Request for Review

Please find below the response to the request for review formulated for the CDM project with the registration number 1319. In case you have any further inquiries please let us know as we kindly assist you.

Response to the CDM Executive Board

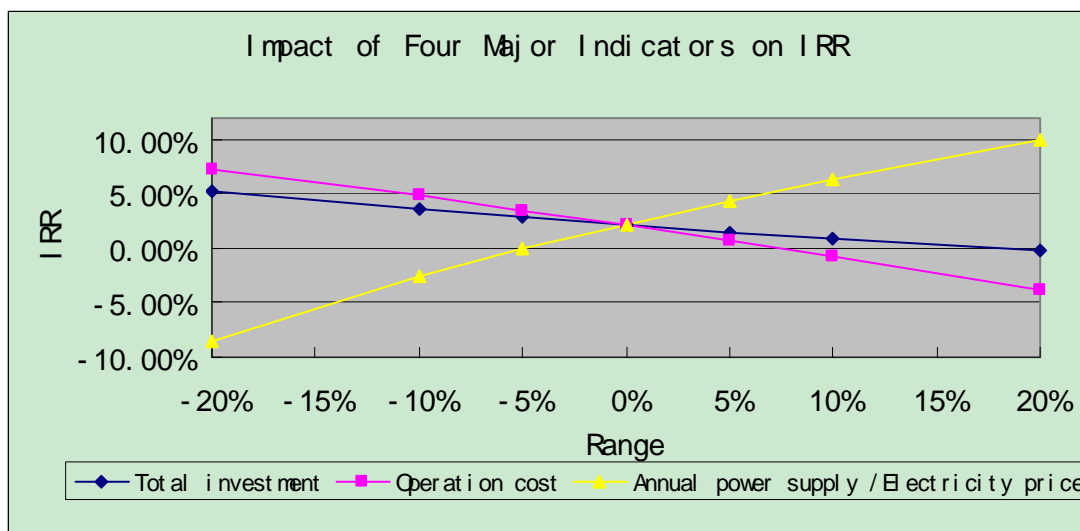
The DOE shall further clarify how they have assessed and verified the sensitivity analysis and the validity of its assumptions.

Firstly, it is reasonable to believe that total investment and operation cost would not decrease, since price level represented by Consumer Price Index (CPI) in China has been increasing sharply these years especially in 2007. CPI of first 3 quarters in 2007 averagely increased 4.2% compared with the same period in 2006. ⁽¹⁾ Price index of industrial products also increased more than 2% in 2007. ⁽²⁾ Therefore, it is reasonable to believe that Total investment and operation cost would not decrease in the foreseeable future.

The annual power supply would not increase since the calculation is based on the full load of the generators. Before the project started, Project Owner had studied carefully on the generators chosen. Annual operation hours of the generators would not exceed 6000 hours in the long run. As CMM power generation is a new technology, no supplier could guarantee the engine's stable operation for a long time.

As described in PDD, the electricity price change's influence on IRR is the same as that of annual power supply. The electricity selling price set in the power purchase agreement (PPA), which was signed on December 28, 2006 between the Project Owner and the local grid company, is 0.256Yuan/kWh (Annex 9). As announced by China NDRC this December, the electricity price would not increase in the foreseeable future.

Moreover, to further ensure the conservativeness, we even conducted the sensitivity analysis with the four parameters fluctuating between -20% and +20% instead of between -10% and +10%. It can still be concluded that the project IRR is lower than the benchmark IRR. (Refer to the table below)

The answer of the PP can be considered as reasonable and sufficient. The above references to Chinese websites have been checked and verified to contain the claimed information.
